78 South Hill Park

Planning Feedback Response

Diagram 1
Existing kitchen without all appliances

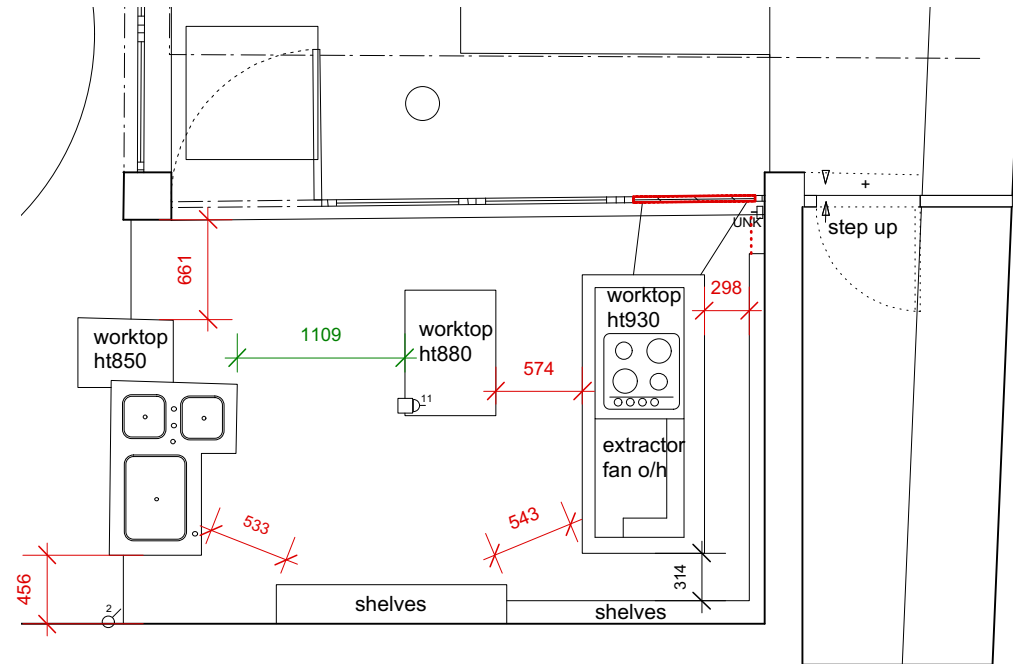
In the kitchen area, whilst the retention and adaption of the existing sink unit into a hob is welcomed, it had been hoped that a higher proportion of original fittings could be kept in conjunction with the reconfiguration of the former larder wall and damp elimination works, including the wall shelving and one more element of the tiled island elements/below worktop storage.

The original kitchen, even without kitchen appliances and contents, was designed significantly below current build regulations minimum distances of 800mm between surfaces. Diagram 1 shows the kitchen in its empty state. All dimensions in red are below building regulations requirements.

2 As Proposed Elevation 2
1:25@A3

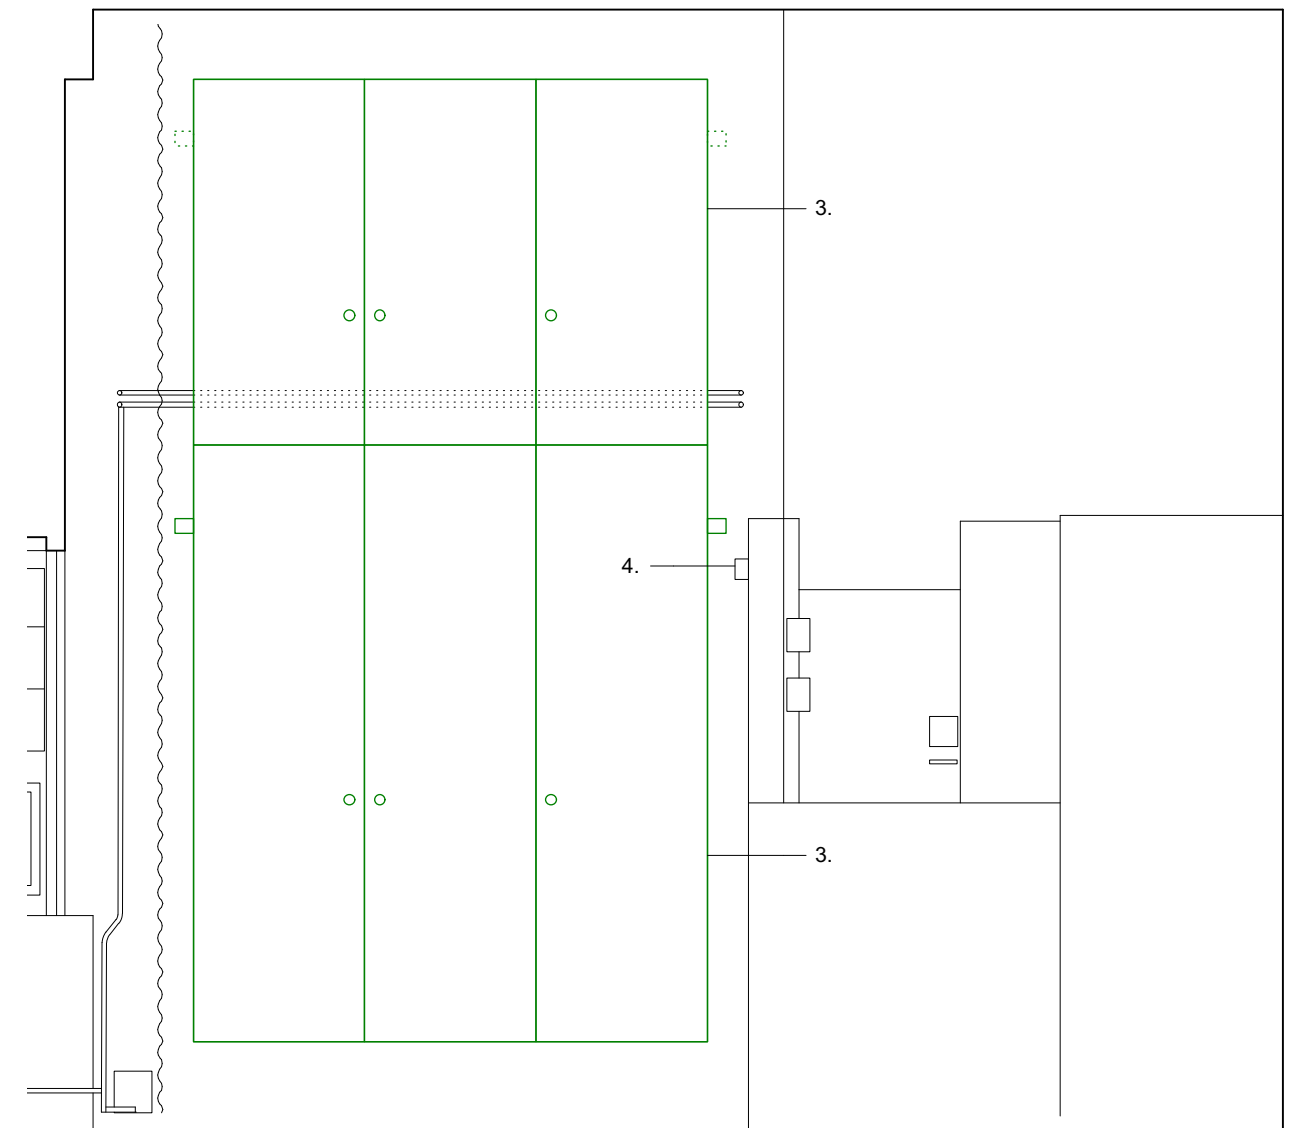
The scheme proposes the removal of noticeable amounts of Housden's own joinery work at ground and first-floor levels, in particular the well-crafted cupboard and shelving units above and adjacent to the bed in Bedroom 1, albeit to be substituted with more generous storage solutions tailored to the applicants' needs. The existing joinery is of value and should be retained as an example of Housden's work. It is noted that a new cupboard proposed to the wall opposite the bed and has been designed to appear similar to the existing shelving and cupboard. However, rather than removing the existing joinery above the bed, can the proposed cupboard opposite the bed be extended further to provide further storage? We would rather see a more standard looking cupboard on this side than lose the existing shelving and cupboard above the bed.

During the design process a taller cupboard idea was investigated in this location but was rejected for two reasons. The house is characterised by the free flowing services that are exposed on the wall. A taller unit would require the cupboard to hide the exposed pipes that run along the wall above. There is no location where joinery covers exposed services and we believe this would be an inappropriate detail to introduce that would disrupt the flow of the services visually. It was also felt that such a large cupboard would visually dominate the room and also not offer much practical storage given how inaccessible this would be. Please see attached the sketch produced during the design stages. We are keen to retain this new cupboard as originally submitted.

Image 1
Photo showing services crossing wall that prevent any new cupboard being taller than the services.

Image 2
Sketch of early study looking at taller unit crossing services that was rejected as a proposal.
